**To:** Design Review Board  
**From:** Aoife Blake, Associate Planner  
**Date:** July 25, 2022  
**File No.:** DRV22-00466  
**Subject:** **SWYFT APARTMENTS  
DESIGN RESPONSE CONFERENCE**

# SWYFT APARTMENTS

DESIGN RESPONSE CONFERENCE

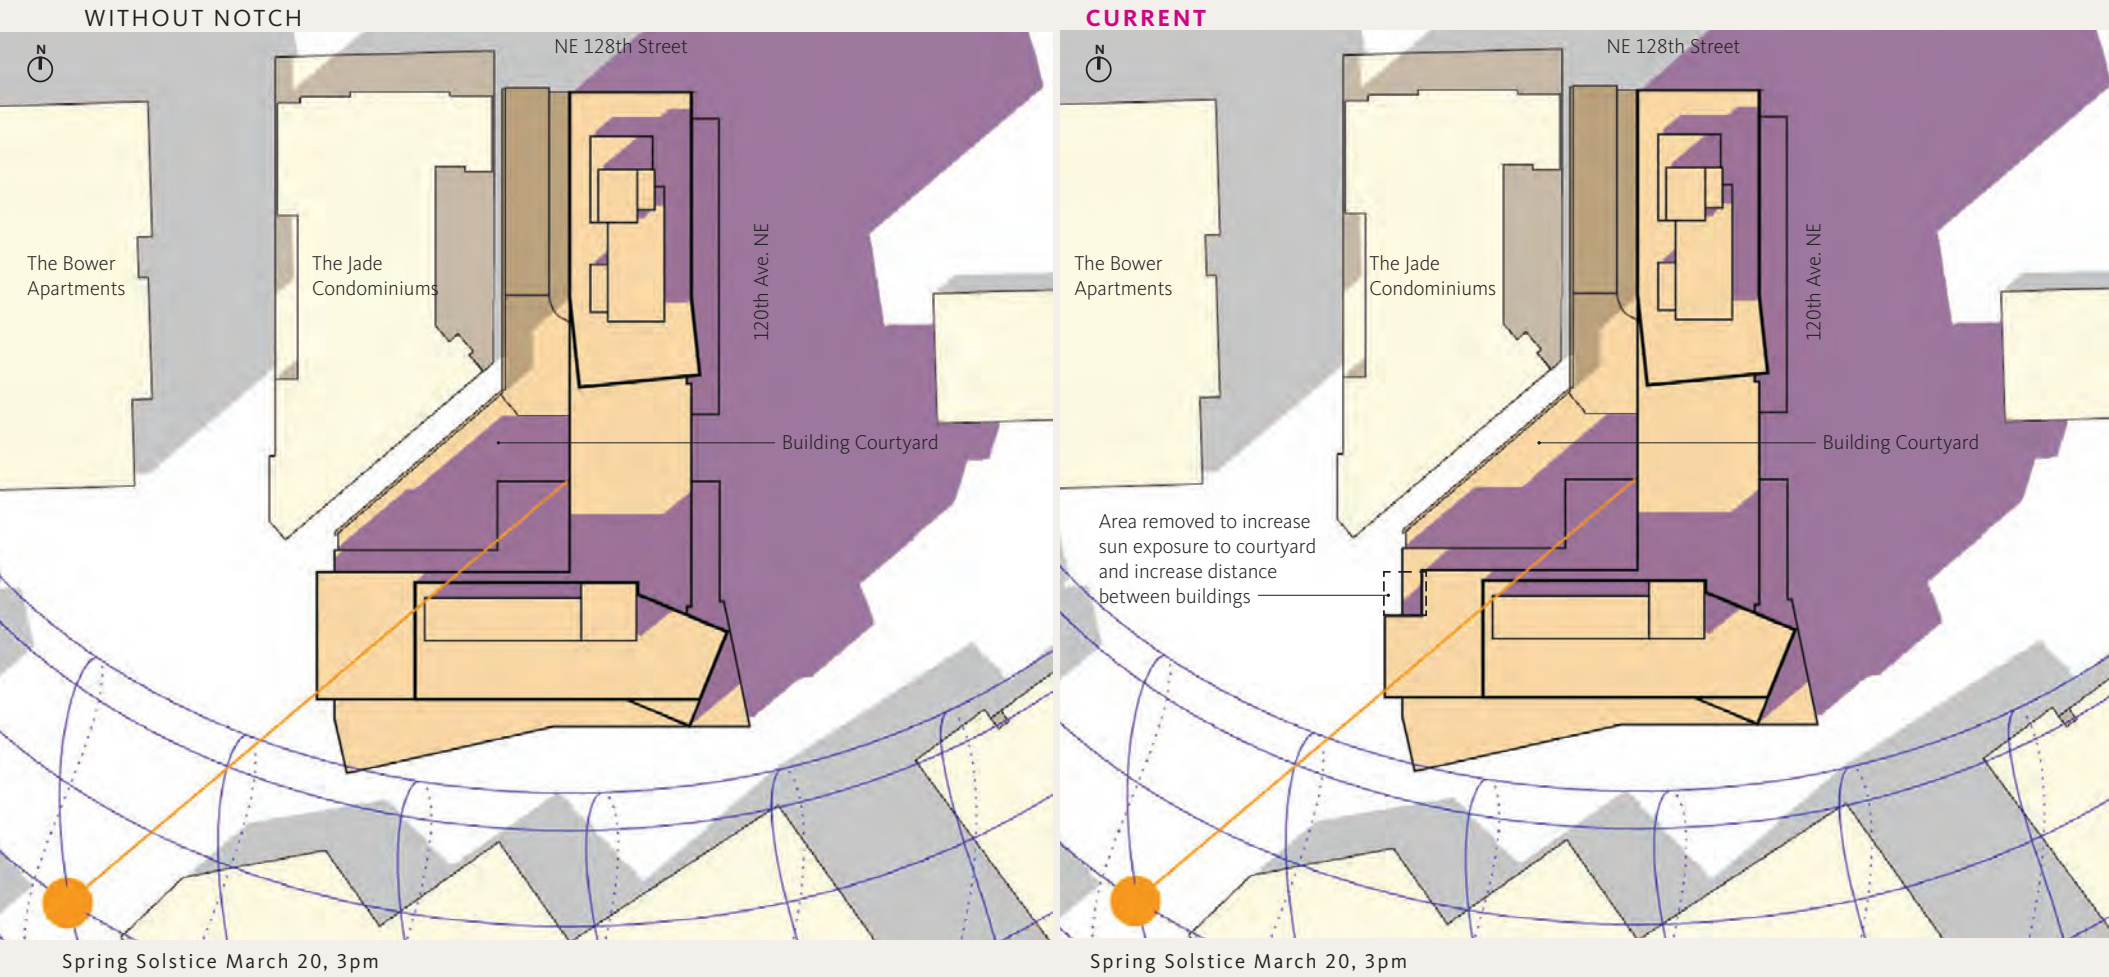
DRB noted some issues around the suitability of the mass on the north side and around how to mitigate the mass of the building. They suggested more refinement is needed as the project design develops to break up the mass of the building. Encouragement to look at a “two-tower” massing concept for complimentary scale to adjoining neighborhood. The applicant was encouraged to explore design approaches in the SW corner of the building, suggesting narrower and greater height.

Request to further refine the South building to address light and privacy to the Jade and courtyard. DRB expressed concern in terms of light and privacy in relationship to the Jade wanted further exploration.

The design team has incorporated a “two-tower” scheme by making refinements to the southern mass through several design changes:

- 01 The upper levels were made more narrow, locking the volume into the SW corner and breaking up the upper level massing.
- 02 The tower was extruded upward by two levels to better compliment the adjoining neighborhood and provide a more fluid transition in height between the existing building on the South and the two proposed stepped tower masses.
- 03 Removed podium mass to increase distance at adjacent building,
- 04 Increased level of privacy and increasing solar penetration
- 05 Facade articulation applied to further break down buildings masses into distinct elements
- 06 Refinement of pedestrian frontage incorporating detail and art
